**Summary Updates for Decommissioning Risk Study
and Comments on NEI Review**

Structural Integrity of Spent Fuel Pool Structures Subject to Heavy Loads Drops

NEI Comments: (Section 3.2.4, page 31 to 36)

Figure 4 -
risk
ion scheme
NUREG/CR

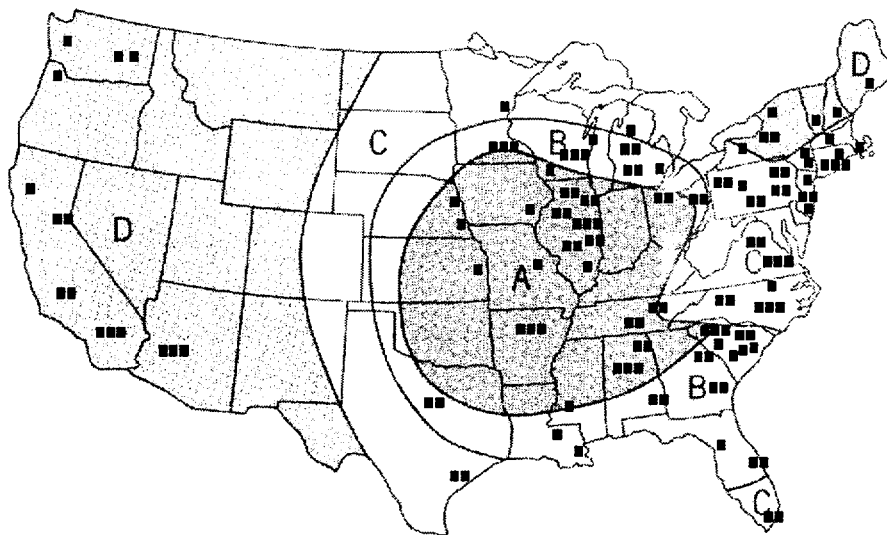
NEI is correct in that the value presented was for the highest tornado region. The exceedance values are best estimate. Because of the rush to release the report, some last minute changes did not get into the draft as released, and 5.6×10^{-7} per year (exceeding an F4) is the correct value. It is appropriate to use a regionalization even if a region (state) has no sites. For example, if Oklahoma is not considered, the value drops to 5.4×10^{-7} per year.

The revised report will include the following table and figure to show the regional variations:

Figure 4 -
risk
ion scheme
NUREG/CR

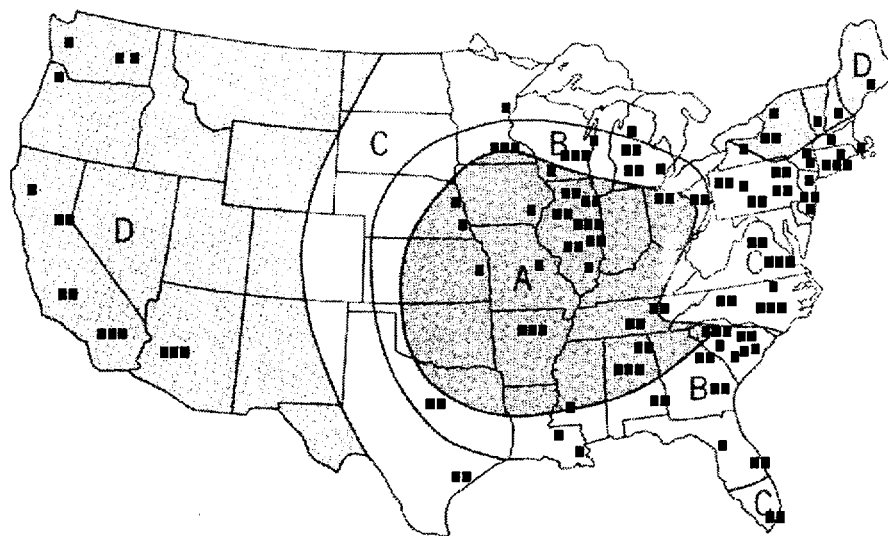
NEI is correct in that the value presented was for the highest tornado region. The exceedance values are best estimate. Because of the rush to release the report, some last minute changes did not get into the draft as released, and 5.6×10^{-7} per year (exceeding an F4) is the correct value. It is appropriate to use a regionalization even if a region (state) has no sites. For example, if Oklahoma is not considered, the value drops to 5.4×10^{-7} per year.

The revised report will include the following table and figure to show the regional variations:
